# BEVERLY S. SHEFFIELD NORTHWEST DISTRICT PARK – POOL RENOVATION

AUSTIN, TEXAS  
PARKS AND RECREATION DEPARTMENT  
DESIGN COMMISSION PRESENTATION  
OCTOBER 23, 2023

# TAS Assessment Report

## Facility Name: Beverly S. Sheffield Northwest Municipal Pool

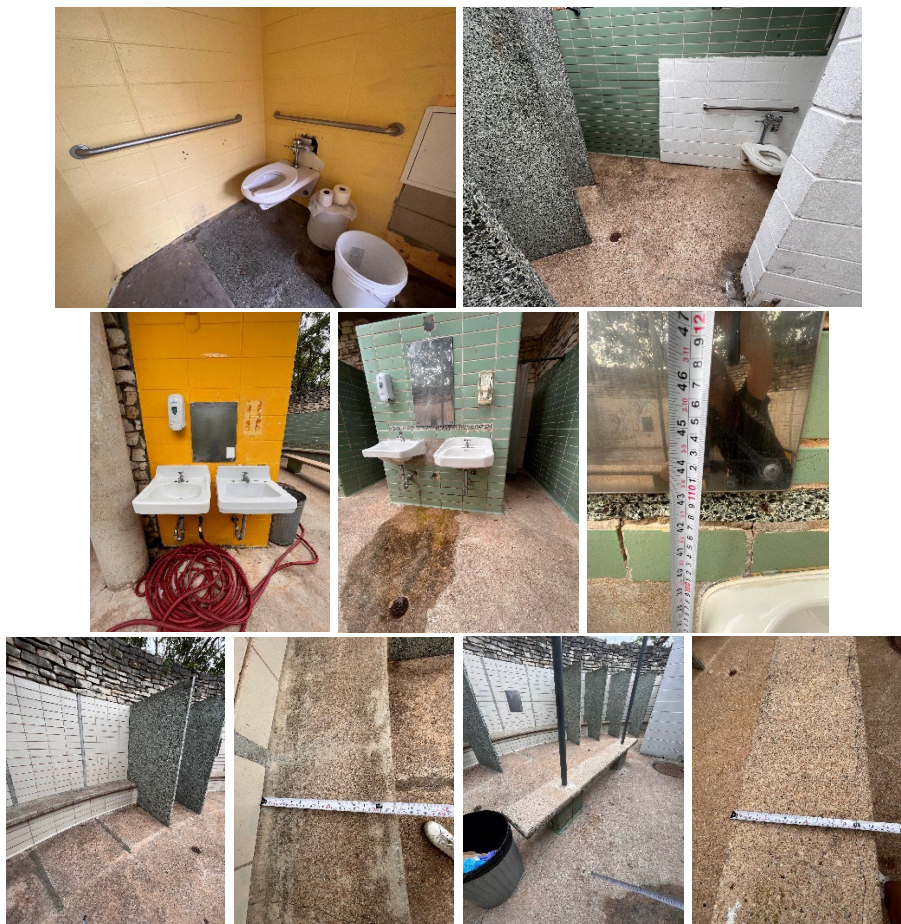
- **Comment 9:** In the restrooms/dressing rooms the following violations were found:
  - In the men's single user restroom, there is no compliant toilet paper dispenser.
  - In the men's single user restroom, the flush control is not installed on the open side of the water closet.
  - In the men's and women's restrooms the lavatories do not provide drainpipes insulation to protect against contact.
  - The soap dispensers over the lavatories are not installed at compliant reach range.
  - The mirrors over the lavatory are installed higher than 40 inches maximum allowed.
  - The complaint single user restroom does not have the 4<sup>th</sup> wall with door, so privacy is not provided, as it is provided for the other compartments.
  - The benches are not of a compliant type.

**603.3 Mirrors.** Mirrors located above lavatories or countertops shall be installed with the bottom edge of the reflecting surface 40 inches (1015 mm) maximum above the finish floor or ground. Mirrors not located above lavatories or countertops shall be installed with the bottom edge of the reflecting surface 35 inches (890 mm) maximum above the finish floor or ground.

**604.2 Location.** The water closet shall be positioned with a wall or partition to the rear and to one side. The centerline of the water closet shall be 16 inches (405 mm) minimum to 18 inches (455 mm) maximum from the side wall or partition, except that the water closet shall be 17 inches (430 mm) minimum and 19 inches (485 mm) maximum from the side wall or partition in the ambulatory accessible toilet compartment specified in 604.8.2. Water closets shall be arranged for a left-hand or right-hand approach.
